March 23, 2023

Re: CEI Response to Fire Life Safety Review dated January 20, 2023  
QNC – SP20-118  
Parker and Pine F1 L4  
Parker, Colorado

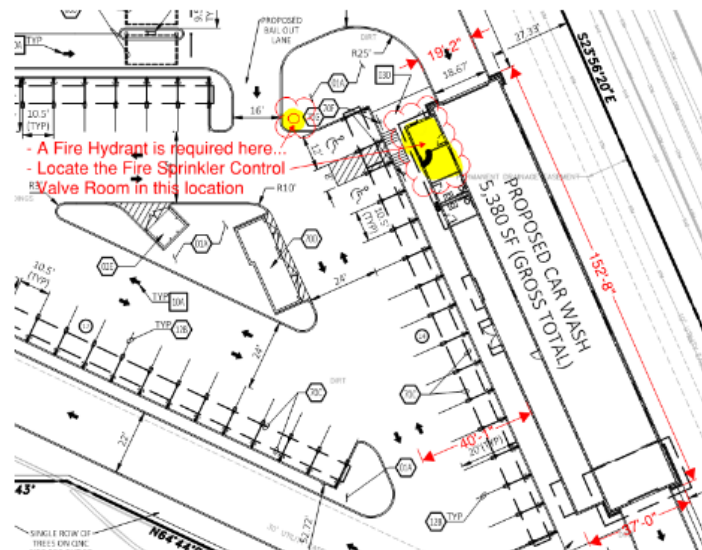
6. Based upon the size of the building (actual building 153'-0" x 37'-0"), it is not possible for the applicant to provide the required access to all portions of the building, as noted in [18 IFC 503.1.1 Buildings and Facilities]. This section states that "the fire apparatus access road shall comply with the requirements of this section and shall extend to within 150 feet of all portions of the facility and all portions of the exterior walls of the first story as measured by an approved route around the exterior of the building or facility". Based upon the size of the building,  $153' + 37' = 190$  feet (plus another 40 feet to center of the access that is perpendicular to the building), the access to all portions of the building would be approximately 230 feet... the requirement cannot be met. *Partially satisfied; applicant has not noted, acknowledged, or addressed with current submittal specific to this response though the plan set does appear to have addressed the fact that the building is required to be sprinklered. The applicant will address all requirements noted in this letter and response both in writing as well as in the documentation when resubmitting. Note – The riser room shall be located closer to the n/w corner of the building... in closer relationship to the required fire hydrant.*

The code does allow the fire code official to extend this access on the basis that the building is fully sprinklered per NFPA 13, as required by [18 IFC 903.1.1]. A sprinkler suppression system, installed in accordance with NFPA 13, is required for this building. *Not satisfied; applicant has noted/acknowledged/addressed with the third submittal though the applicant has stated that this issue is to be "addressed by others". Clarification as to this response is required. Note - The location of the riser room is acceptable. Satisfied; The riser room location will be accepted for this project.*

Note – The applicant shall be aware that the measurement starts center line of the access road perpendicular to the building and a at the center of the apparatus. Further, as hose does not bend at 90-degree angles, the measurement is much longer. Given that the measurement provided did not address the wing walls, stairs, etc., the hose pull extends even further. Given that the building is 153' long and 37 feet wide, the hose pull alone would be 190'. Add the 40 feet to the vehicle, and the hose pull for half of the building would be 230'. When adding in the radius of the hose (as it lays out) the configuration of the site would add an additional 50' to 75' to meet the hose pull requirement...

CEI Response: Noted. The riser room is shown on civil drawings and latest Architect Plan Set prepared by CSHQA.

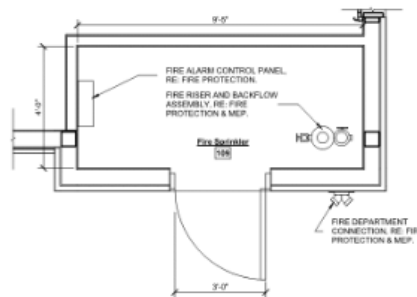
7. The applicant is required to provide fire hydrant in the location shown in item #5; address as required. *Not satisfied; applicant has provided a fire hydrant though it is shown to be on a dead-end line (not looped as required if it is to share the same line as the underground fire line) along with the underground fire line. Satisfied; applicant has noted/acknowledged/addressed with the third submittal*

CEI Response: Noted. Thank you.
